Item Name: Crosstube Assembly, Mid Fwd

DART AEROSPACE LTD	Work Order:	98192
Description: Crosstube Assembly, Mid Fwd	Part Number:	D206-667-147TRN
Inspection Dwg: D206-667-147 Rev: A		Page 1 of 2

DRAWING NO. D206-667-147	TITLE CROSSTUBE ASS'Y (206L MID FWD)	REV. A	DART AEROSPACE LTD ENGINEERING ORDER		D.E.O. NO. D206-667-147-A-1	SHEET NO. SHEET 1 OF 1	SCALE NTS
DRAWN <i>qp</i>	CHECKED <i>ASS</i>	MFG. APPR. <i>JB</i>	APPROVED <i>MD</i>		DE APPR. <i>MD</i>		
DATE 11.07.15	DATE 11.07.20	DATE 11.07.21	DATE 11/07/21		DATE 11.07.21

DRAWING NO. D206-667-147	TITLE CROSSTUBE ASS'Y (206L MID FWD)	REV. A	DART AEROSPACE LTD ENGINEERING ORDER	D.E.O. NO. D206-667-147-A-2	SHEET NO. SHEET 1 OF 1	SCALE NTS
DRAWN AJS	CHECKED	MFG. APPR.	APPROVED	DE APPR.		
DATE 12.08.02	DATE 12.08.02	DATE 12.08.02	DATE 12.08.02	DATE 12.08.02

DETAIL P
BONDING STRAP INSTALLATION 2 PL

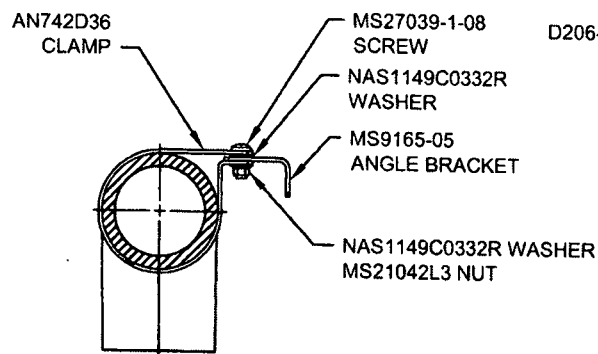
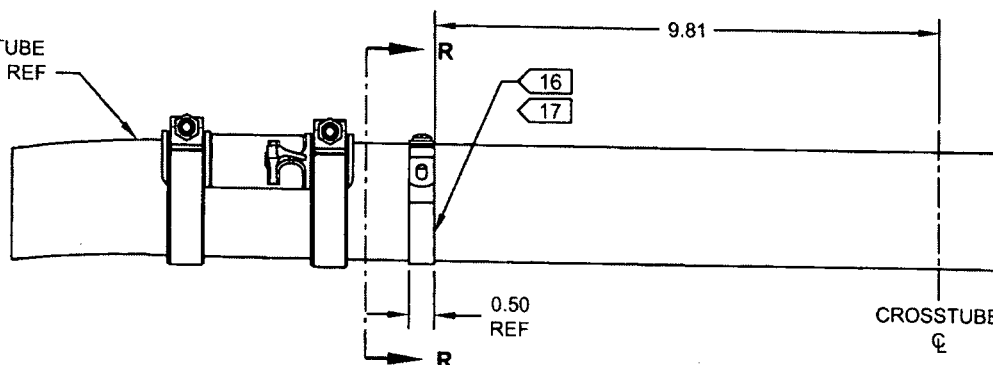
ADD ELECTRICAL GROUNDING STRAP

- 16) MASK AREA UNDER CLAMP PRIOR TO PAINTING
- 17) SEAL EDGES WHERE AN742D36 CLAMP MEETS WITH THE CROSSTUBE USING SIKAFLEX-241/-291 OR MIL-S-8802 CLASS B2 OR PROSEAL 890 SEALANT
- 18) PERFORM RESISTANCE CHECK TO ENSURE MAX RESISTANCE IS 10 MILLIOHMS
